Change Order

PROJECT: <i>(Name and address)</i> Hopkins County Auxiliary Gym Additions to Existing High Schools	CONTRACT INFORMATION: Contract For: General Construction Date: March 20, 2023	CHANGE ORDER INFORMATION: Change Order Number: 004 Date: October 30, 2023
OWNER: <i>(Name and address)</i> Hopkins County Board of Education 230 South Seminary Street Madisonville, KY 42431	ARCHITECT: <i>(Name and address)</i> Sherman Carter Barnhart Architects PLLC 144 Turner Commons Way Suite 110 Lexington, KY 40508	CONTRACTOR: <i>(Name and address)</i> Danco Construction 3201 Interstate Drive Evansville, IN 47715

Re: BFW review of RFP for work associated with RFI#16 (Water Line Options)

Re: **Change Order Request 003**
Madisonville North Water Line Options
Hopkins County Auxiliary Gymnasiums

SHEET
C13.0

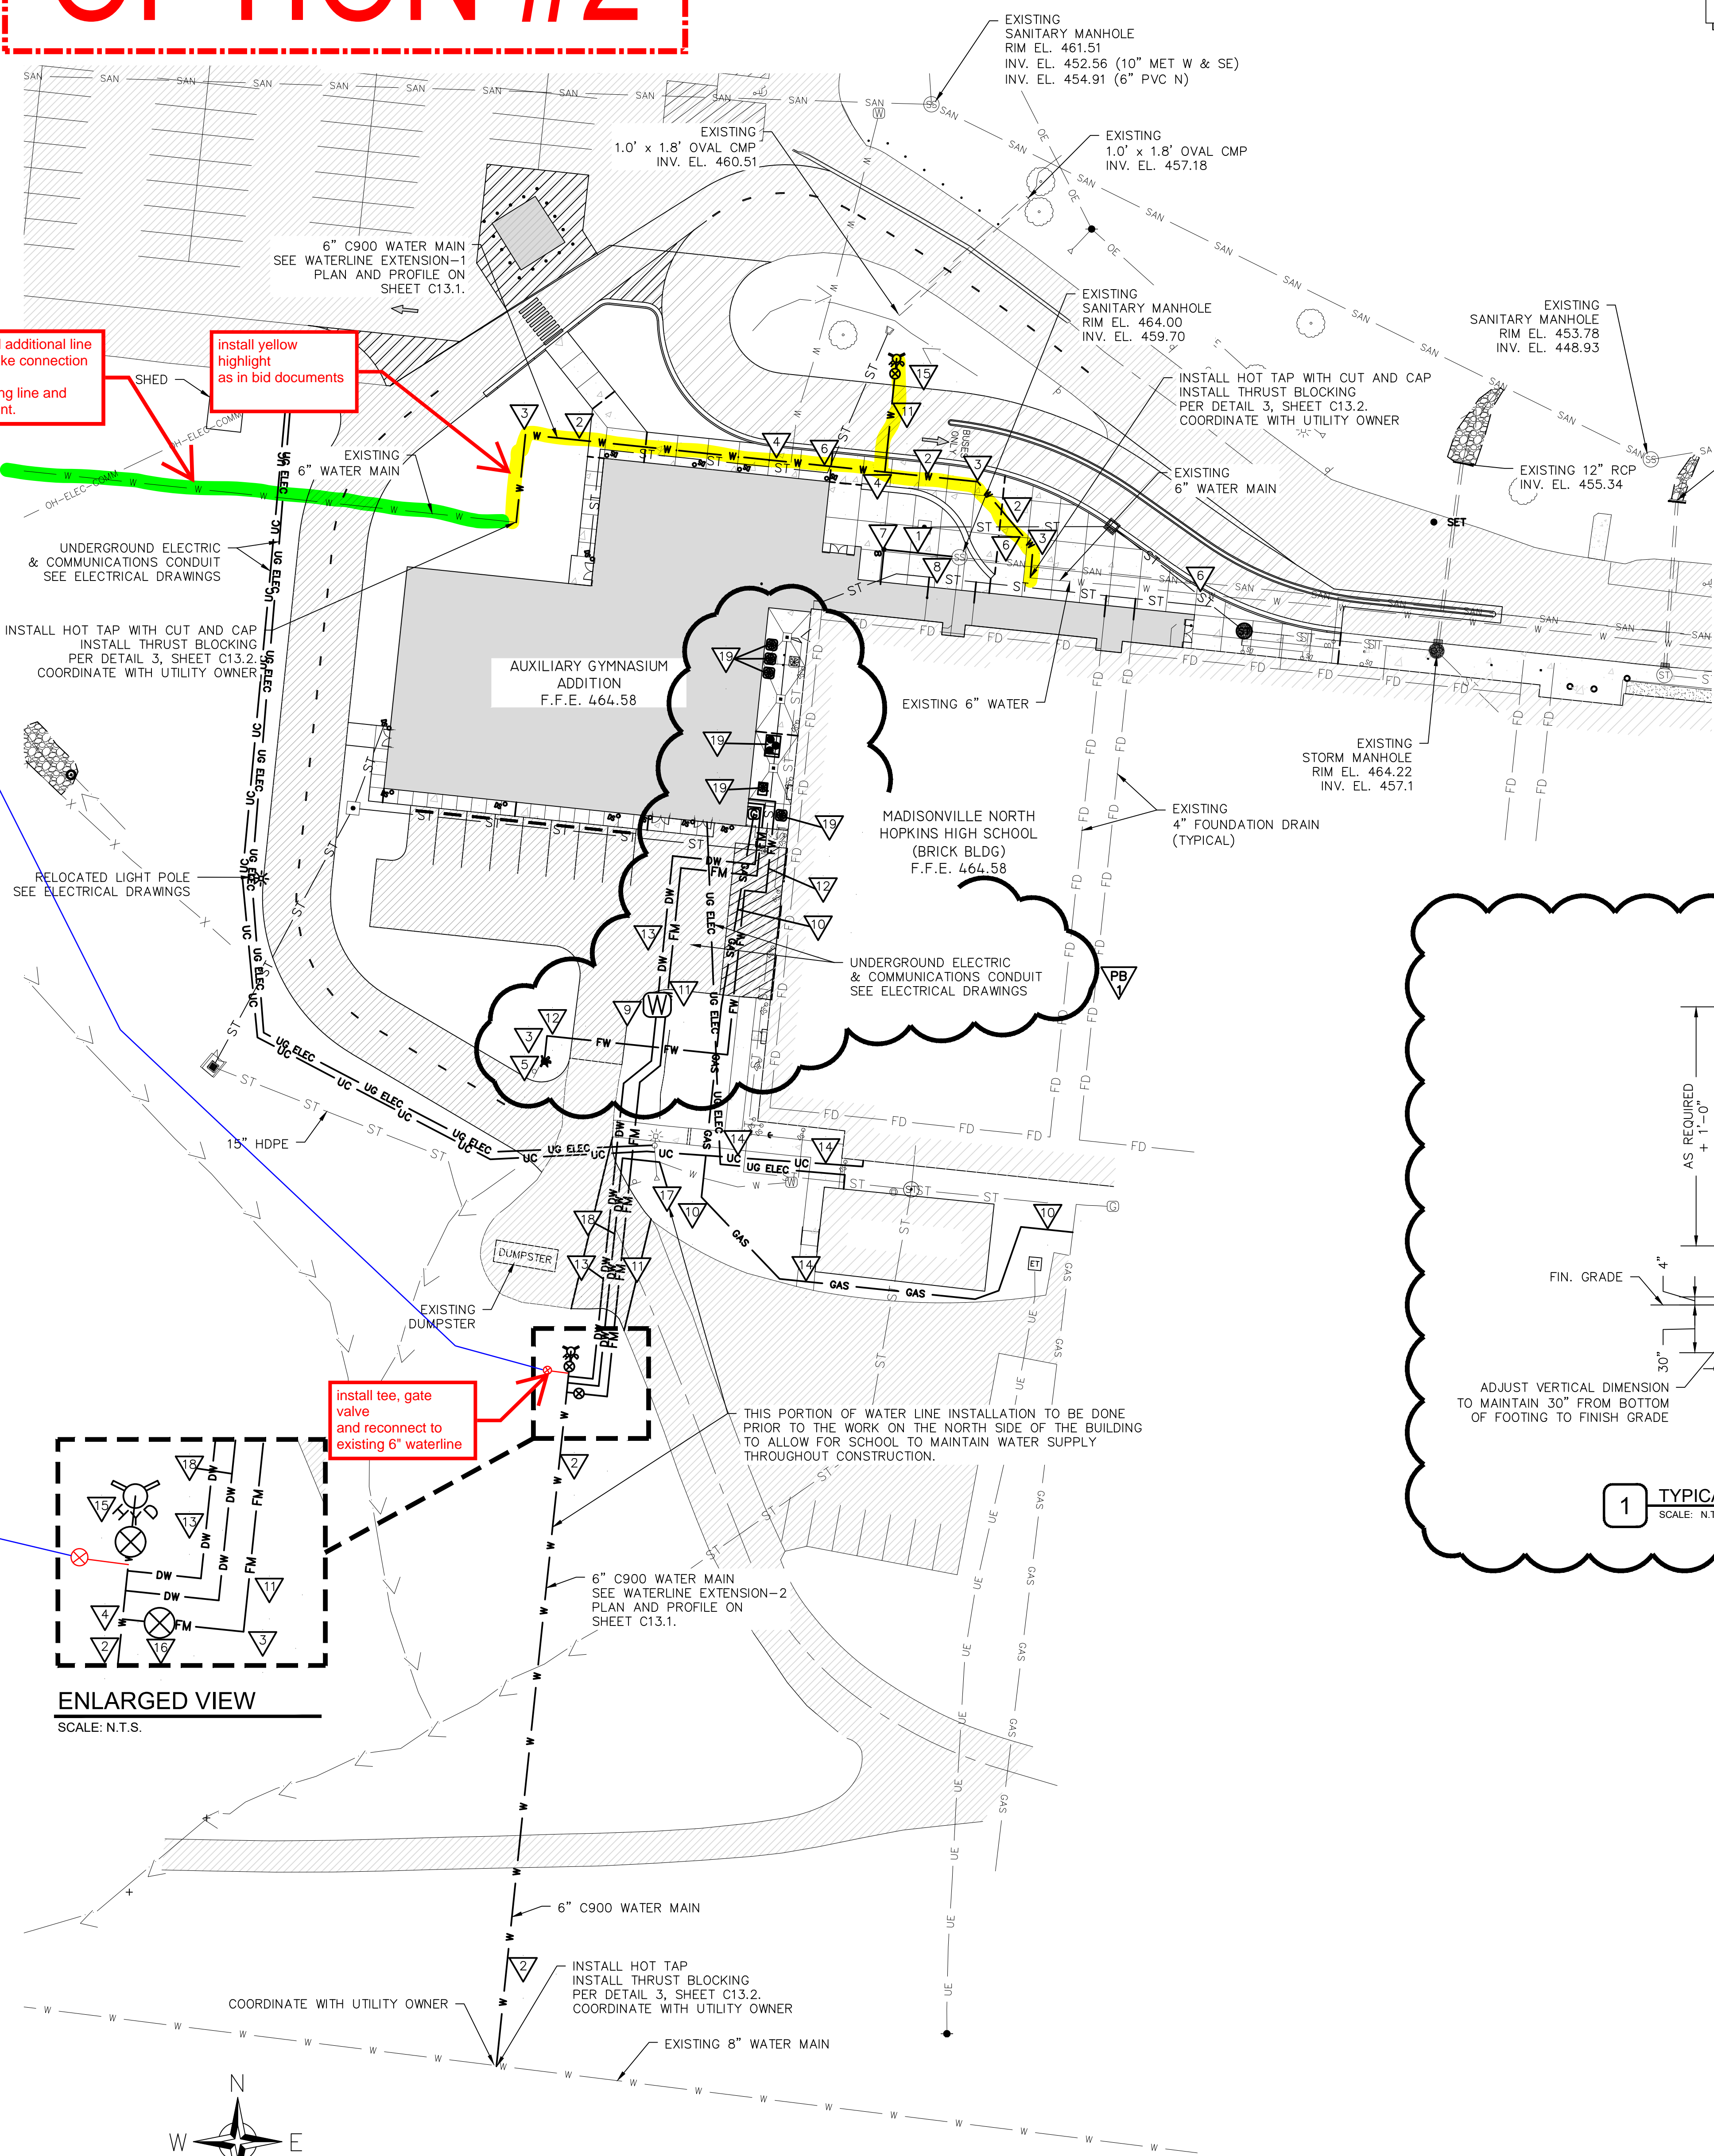
OPTION #2

Install additional line to make connection at existing line and hydrant.

Install yellow highlight as in bid documents

Install tee, gate valve and reconnect to existing 6" waterline

On the north side of the school, Install 6" C900 line per plan C13.0 and delete one hot tap and one cut and cap existing water main. Add Fire Hydrant and Auxiliary 6" Valve at the end of the new line. (where it reconnected on the original plan). On the south side of the school. Install Tee and Valve and reconnect to the existing 6" line going to the Hydrant and Grandstand water service at the football field.
